UNITED STATES PATENT AND TRADEMARK OFFICE

Office Action Summary	Application No. 10/773,160	Applicant(s) COATES, FREDRICA V.	
	Examiner Karin M. Reichle	Art Unit 3761

DETAILED ACTION

FIG. 9.

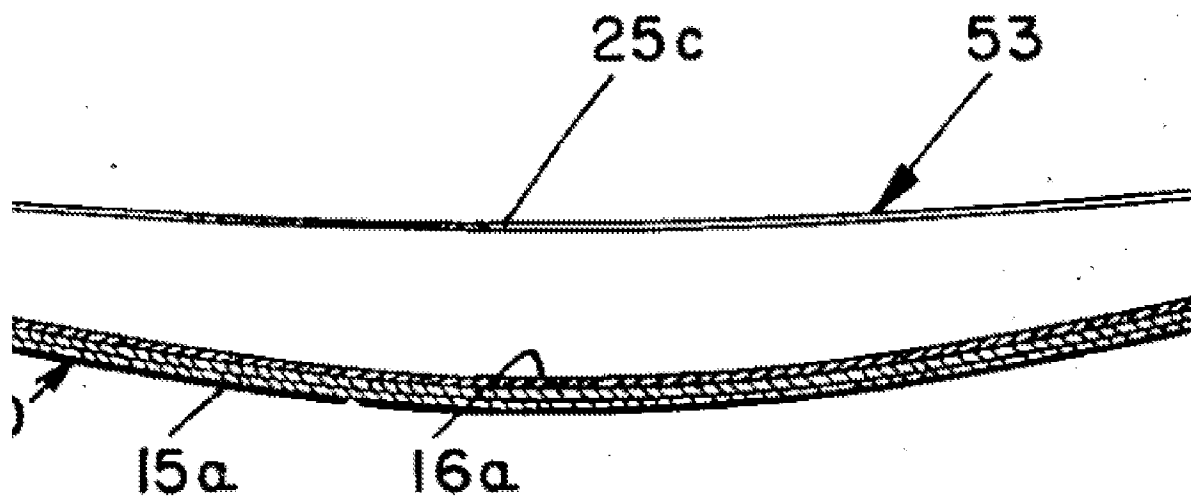
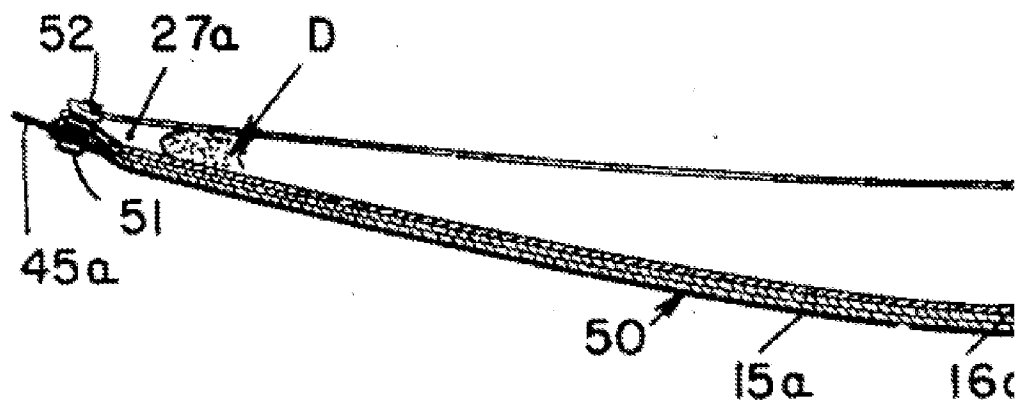
Claims 20 and 22-23: See Claim Language Interpretation section supra hereinafter also referred to as CLI and Figures 7-9, and note the blow-ups of Figure 9 in Appendix A attached to this action, col. 1, line 55-col. 2, line 6, col. 2, lines 14-31 and col. 3, lines 23-43, i.e. the first part/outer layer is the outer layer of 15a, the first part/anchor layer is the inner layer of 15a, the stitching is 17. The outer layer and anchor layers are separate fabrics layers, the former shaped to conform to a buttock and leg region of the user, see Figures, and the latter having a shape conforming to that of the former. The second part/pocketed sling is 53 which includes four sides

and is detachably coupled to the anchor layer but not directly detachably coupled to the outer layer, i.e. only indirectly so coupled, by releasable fasteners which are snap fastener of two portions 51, 52 located respectively on the anchor layer and sling, see blow up in Appendix A, col. 2, line 7 and col. 3, line 21, elements 20-21 as shown in Figure 2, col. 3, lines 31 and 36-41 and elements 20a, 21a, 50-51 as seen in Figures 7-9. The sling extends from the anchor layer on the inner side of the undergarment when the undergarment is worn to form a pocket for retaining a fluid absorbent pad, i.e. diaper D, facing inwardly away from the anchor layer. The sling is displaced inwardly from corresponding sides toward the center of the anchor layer and inwardly from the stitches between the anchor layer and the outer layer at, e.g., 7b, 7c, 8b, and 8c. It is noted that the entire periphery/all portions of all four sides of the sling is/are not required to be so inwardly displaced from the entire periphery of the anchor layer. However also note the position of 31 in Figure 3 and the position of 51 and 52 in Figures 7-9 with regard to stitching 17. The outer layer overlies fasteners on the anchor layer, e.g. 20a, 21a, 50 and/or 52. It is noted that the fasteners which are overlaid by the outer layer are not required to be the releasable fasteners on the sling and anchor layer. It is also noted that the fasteners are not required to be completely overlaid, i.e. unexposed, by the outer layer, e.g. the outer layer overlies a portion of the fasteners 51, 20a, 21a which are on the inside thereof and fasteners 52 when the garment is unfastened and overlies completely some fasteners, e.g. 20a, when the garment is fastened, see Figure 1.
